Serial: RA-23-0154  
July 20, 2023

Catawba Nuclear Station, Unit Nos. 1 and 2  
Docket Nos. 50-413, 50-414 / Renewed License Nos. NPF-35 and NPF-52

**SUBJECT: Response to Request for Additional Information Regarding Proposed Alternative for Pressurizer Welds in Accordance with 10 CFR 50.55a(z)(1)**

**Enclosure 1**  
**Response to Request for Additional Information**

**Figure 1 Finite Element Model**

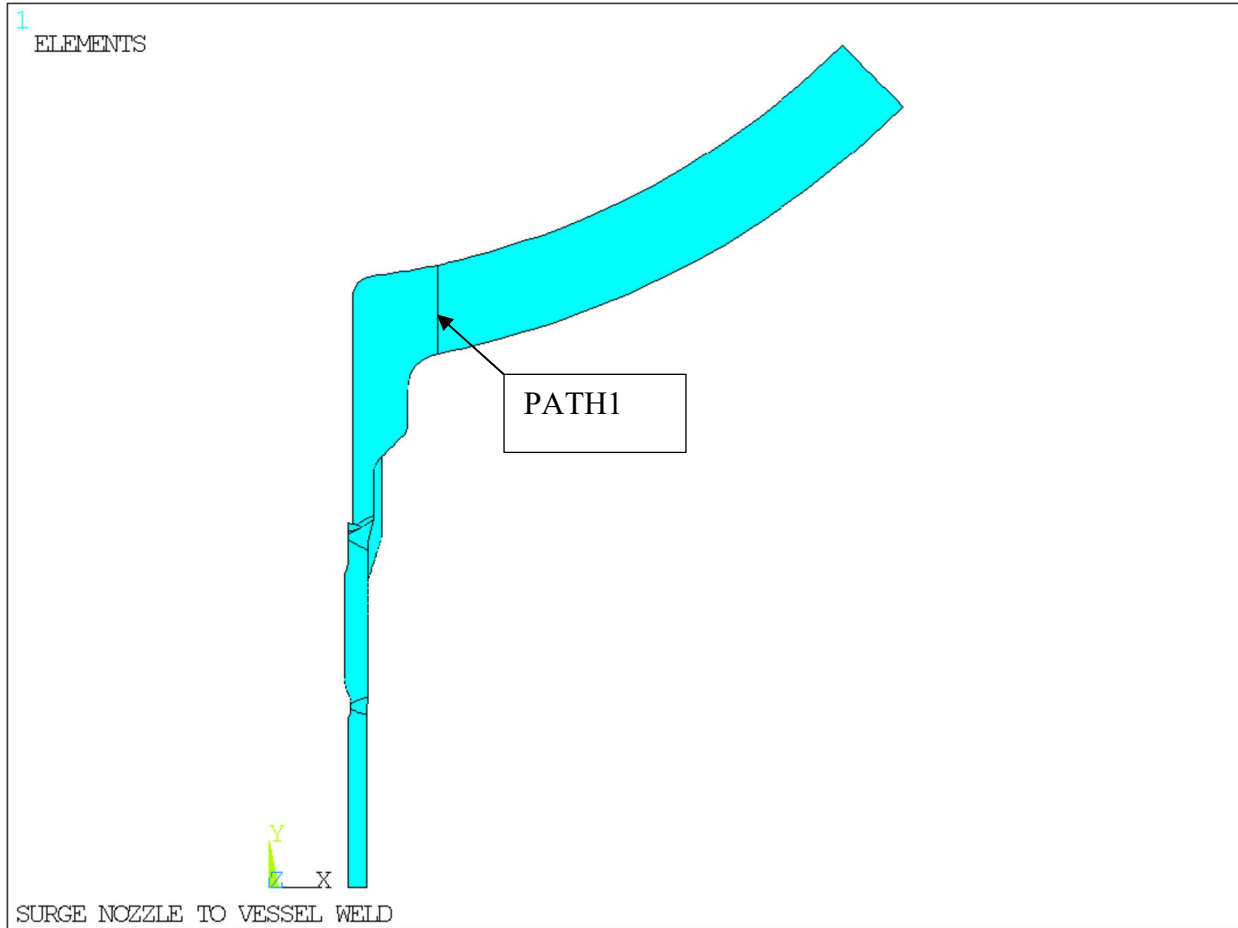
Section 7.1.2.2 of EPRI Report 3002015905 describes the application of piping interface loads due to thermal stratification for the surge nozzle stress analysis. However, in the plant-specific stress analysis for Oconee Nuclear Station Units 1, 2, and 3 in Attachment 7 to the submittal (Structural Integrity Associates [SIA] calculation 2100561.302, Revision 1), piping interface loads due to thermal stratification appear to have not been applied.

Justify not applying piping interface loads due to thermal stratification in the stress analysis in SIA calculation 2100561.302, Revision 1.

A previously developed finite element analysis (FEA) model of the ONS1/2/3 pressurizer surge nozzle and bottom head was used to perform an evaluation to determine the stresses due to thermal stratification interface loads. The model shown in Figure 1 (developed using ANSYS (Reference 1)) includes a portion of the pressurizer bottom head, the surge nozzle, safe end, weld overlay repair and a portion of the surge line piping. A unit moment of 1,000 in-lb (1.0 in-kip) was applied to the free end of the modeled surge piping. The resulting stresses at the nozzle-to-bottom head weld were then scaled to the ONS1/2/3 plant specific maximum thermal stratification moment of  $M = 2,002$  in-kip.

The model in Figure 1 did not extend to this weld location and therefore a hand calculation was used to determine the stresses. The stresses were estimated by dividing the stratification moment by the section modulus of the pressurizer shell.
